2/9/2007

CP2200/1 Rev. C Errata

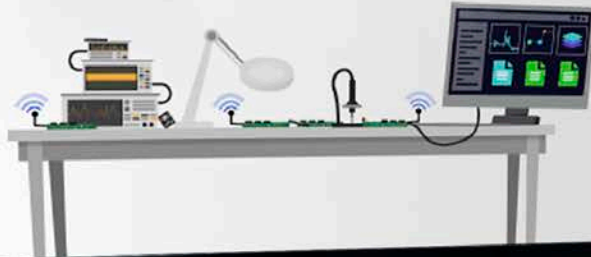
2. **MAC Address Filtering**—For unicast packets received over the Ethernet wire, the receive filter only validates the first 5 bytes of the 6-byte Ethernet MAC Address. Any packet addressed to a device whose MAC address only differs in the 6th byte will be allowed to pass through the receive filter.

Workaround—The Ethernet driver on the host controller should verify that the 6th byte of each packet (i.e., the final byte of the MAC address) matches its assigned MAC address. If it detects a mismatch, the packet should be discarded by writing '1' to the RXSKIP bit.
